**BEFORE THE
LOUISIANA PUBLIC SERVICE COMMISSION
DOCKET U-37764**

Entergy Louisiana LLC, ex parte. 2025 Request to initiate Integrated Resource Planning process pursuant to the General Order (Corrected) dated August 24, 2024 (R-36262).

**THE UNION OF CONCERNED SCIENTISTS' COMMENTS REGARDING ENTERGY
LOUISIANA'S IRP DATA INPUTS**

FIGURE 2 | Economic losses for the top 10 coal plants, 2021-2023

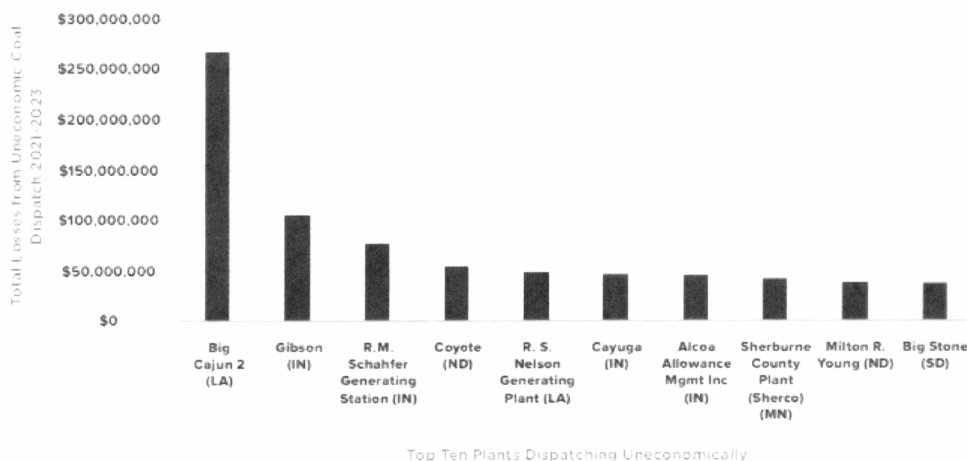
Big Cajun 2 produced the highest economic losses from 2021-2023 out of any other coal plant in MISO, more than twice the losses of the second-highest.²⁷ Note: the graph shows data at the plant level, not unit level.

We recommend ELL break out these losses from the apparent “self-scheduling” of Unit 3²⁸ (along with other coal and higher-cost units such as Nelson 6) in its draft IRP results. The Company could accomplish this by imposing a minimum generation requirement on the unit that resembles recent historic operations, and comparing such results to those in a different sensitivity where the unit is only dispatched economically.

ELL should, at the very least, come up with a plan to stop charging its own customers for Big Cajun 2 Unit 3, as its investment in the unit is just about \$6 million short of being fully depreciated.²⁹ This remaining obligation is far less than the tens of millions in ratepayer losses it

Figure 3. Cumulative Bulk Electricity System Costs, Mid vs. High Data Center Growth, 2026–2041

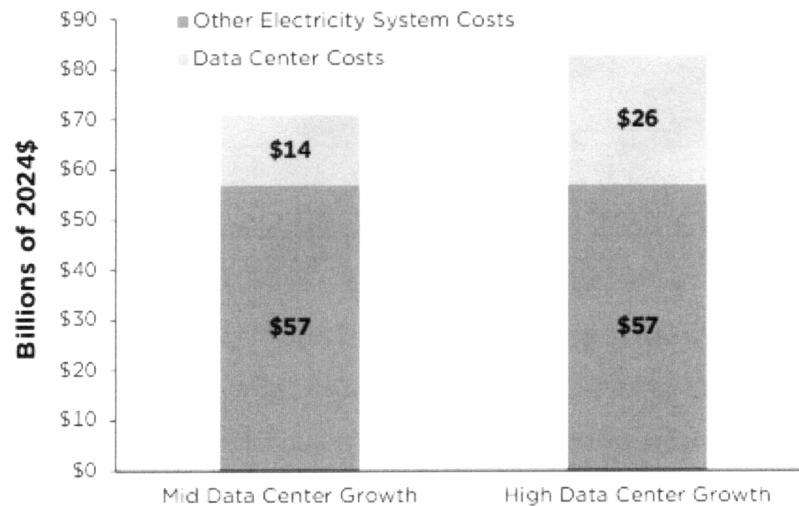
An April 2026 UCS capacity-expansion analysis shows a net present value of about \$14 billion, or 20 percent, of Louisiana’s cumulative wholesale electricity system costs from 2026 to 2041 attributable to data center growth under a ‘Mid Data Center Growth’ scenario (where load grows to about 2 GW). The projected percentage rises to \$26 billion, or 31 percent, under a ‘High Data Center Growth’ scenario (where load grows to about 5 GW).

Essentially, load overestimation could lead to both early retirements and stranded assets, both of which ELL asserts should not be part of this IRP. The Commission should reject this notion. ELL is contemplating approximately \$20 billion in new capital spending for one single data center customer³⁸ that has already shortened its commitment to a four-year lease.^{39,40} There is a massive concentration of risk that could lead to billions in stranded assets for ratepayers. The IRP is the venue where these types of medium- and long-term risks should be assessed.
